S/S Leatherworth
S/S Leicester

Hull Report No. 7898
7955

— S/S Nos 343 and 344 —

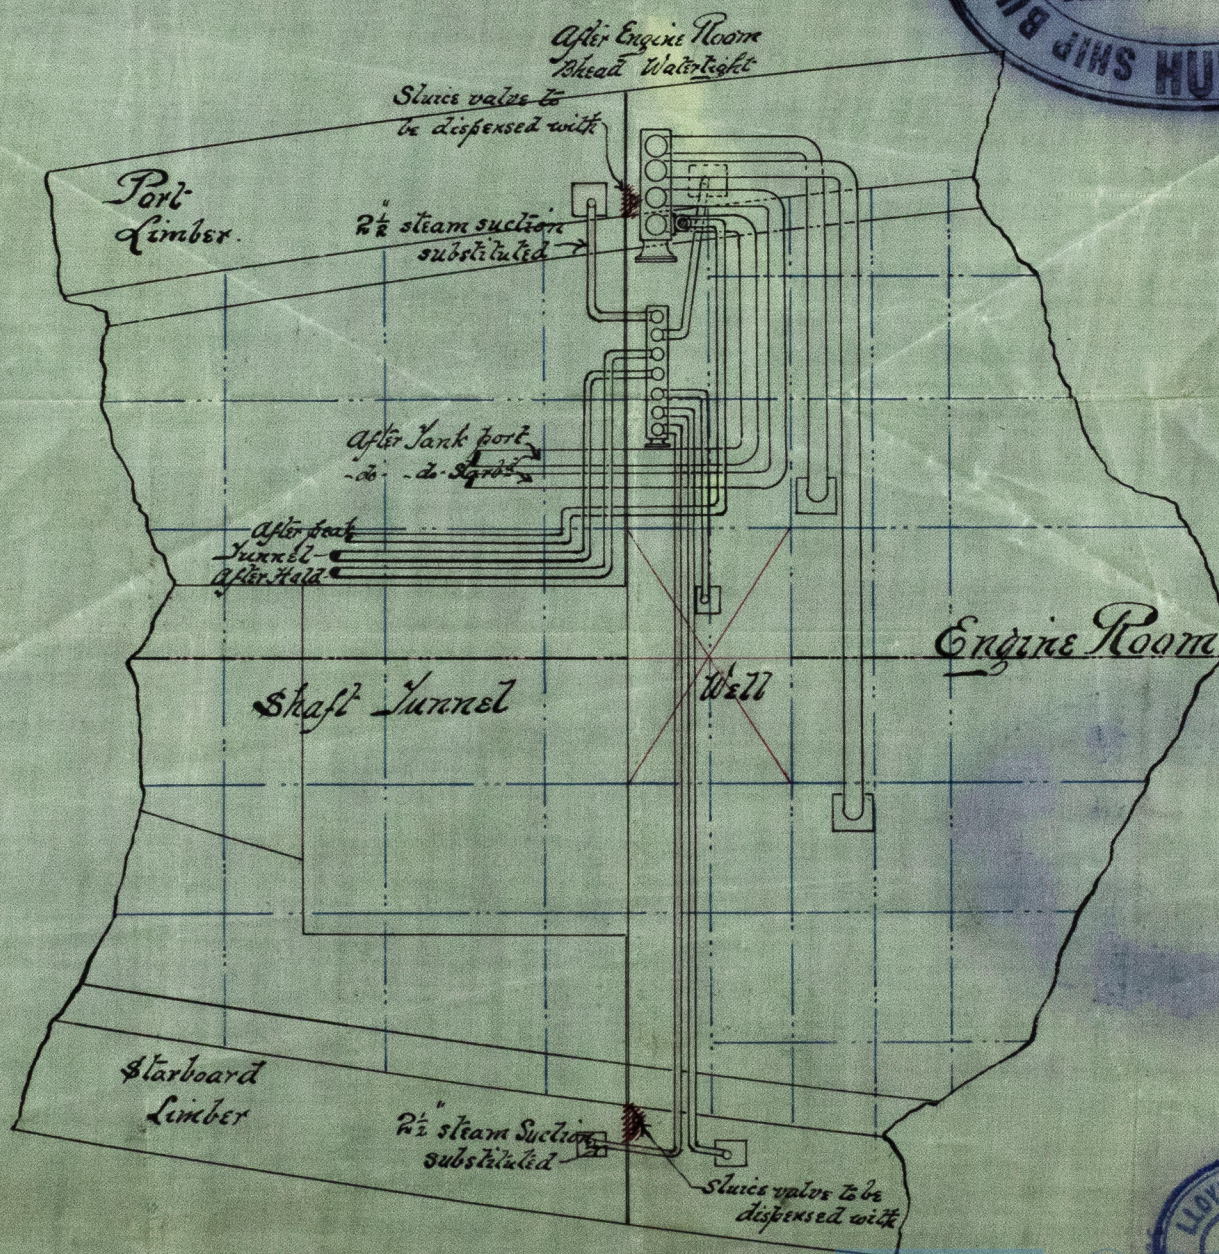
Proposed substitution of steam suction
to each limber at fore end of After Hold in
lieu of sluice valves as submitted and
approved: additional suction tinted red.
